TO:  <b>MODIFIED BY EI 78-039</b> <b>EFFECTIVE 7/17/1978; EI 78-056</b> <b>EFFECTIVE 1/11/1979; EI 80-032</b> <b>EFFECTIVE 1/8/1981; EI 81-046</b> <b>EFFECTIVE 3/4/1982</b>	<h1>ENGINEERING INSTRUCTION</h1> <p>NEW YORK STATE DEPARTMENT OF TRANSPORTATION</p>
Distribution: <input checked="" type="checkbox"/> Main Office <input type="checkbox"/> Regions <input type="checkbox"/> Special	Code: <u>EI 77-57</u>
APPROVED:  Deputy Chief Engineer, Facilities Design Subdivision	Date: <u>12/23/77</u>  Supersedes: MODIFIES EI 77-023 DATE 5/13/77

Subject: STANDARDS & SPECIFICATIONS FOR CONSTRUCTION BARRIERS  
AND BARRICADES

MAINTENANCE AND PROTECTION OF TRAFFIC  
TEMPORARY BOX BEAM BARRIER, AND TEMPORARY CONCRETE BARRIER

TIMBER BARRICADE SYSTEM FOR STRUCTURES

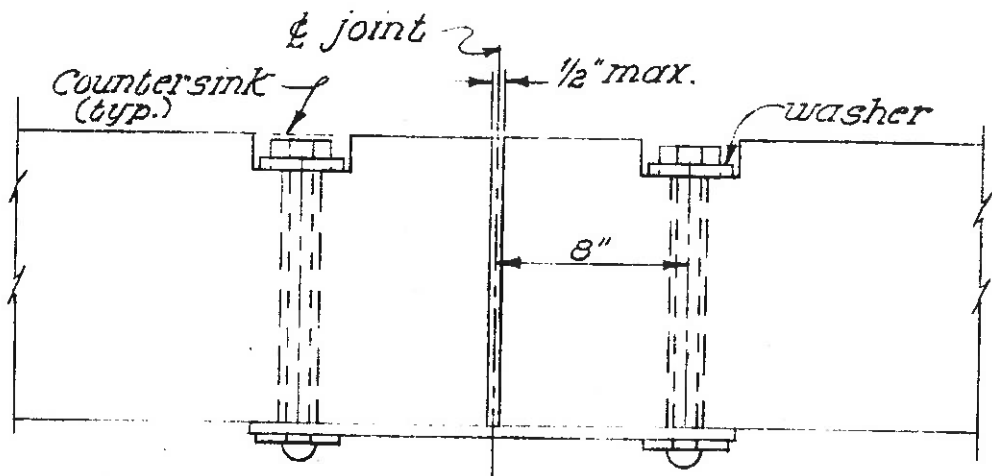
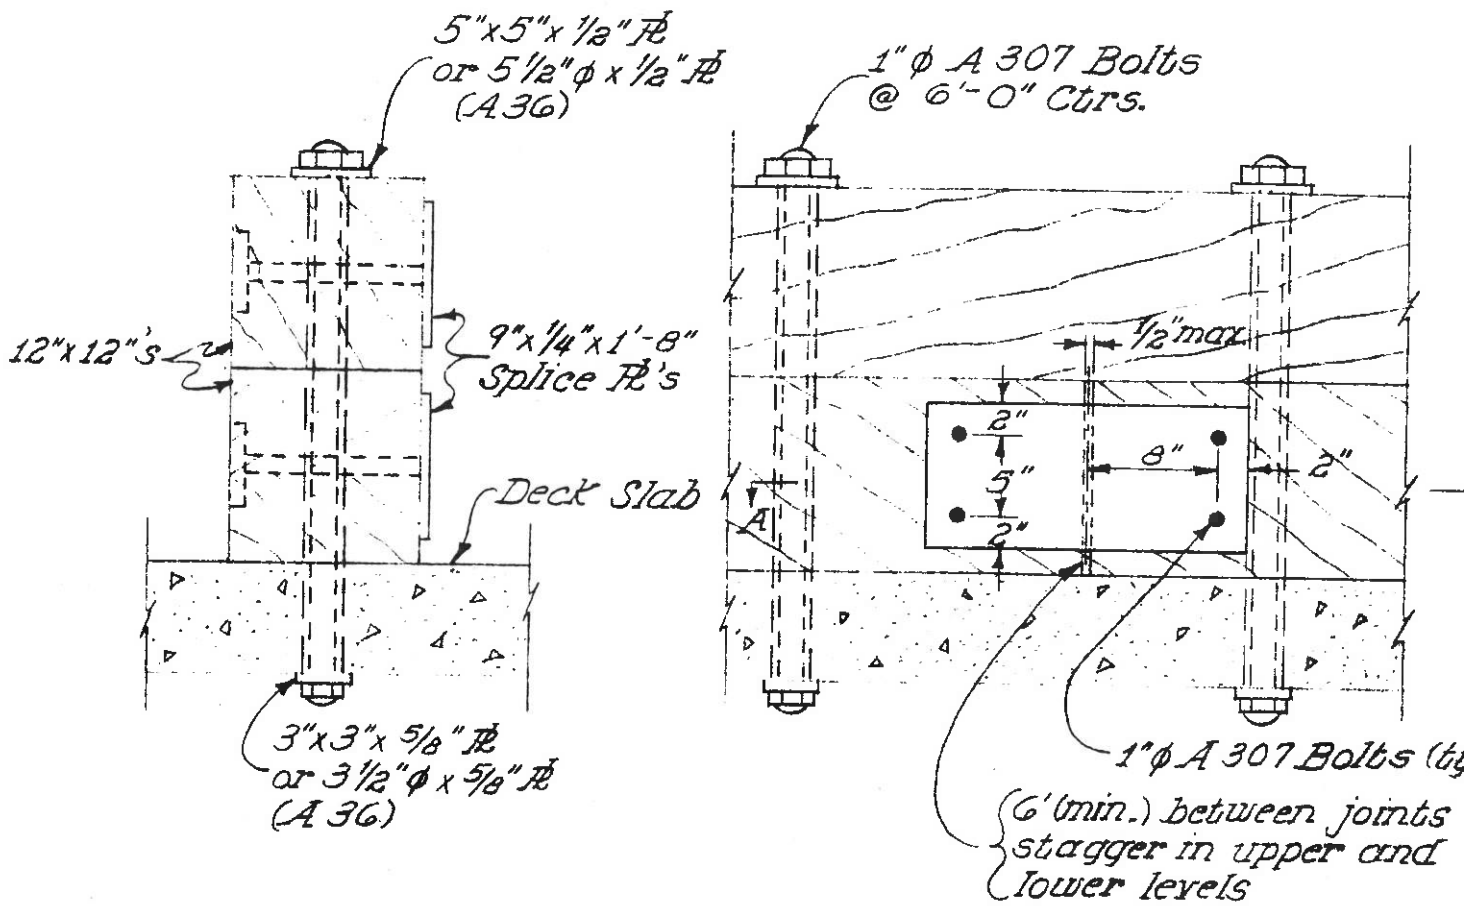
Materials. 12" x 24" Timber Barrier System for structures shall be made from two 12" x 12" rough cut timbers which are free from cracks, splits, or excessive knots and have a minimum length of 12 feet. All other materials shall comply with the requirements of the following specifications:

The temporary timber barrier shall be securely fastened to the structural slab by bolts extending through the structural slab as shown on the plans or directed by the engineer. Holes made in a structural slab, which is to remain in place, shall be drilled with a core drill. Holes made in a structural slab, which is to be removed, shall be made by any method acceptable to the Engineer.

All holes left in the final finished concrete surfaces or in the structural deck as a result of anchoring the timber barrier shall be filled with concrete grouting material in a manner approved by the Engineer. All holes shall be thoroughly cleaned and dried immediately prior to the addition of concrete grouting material.
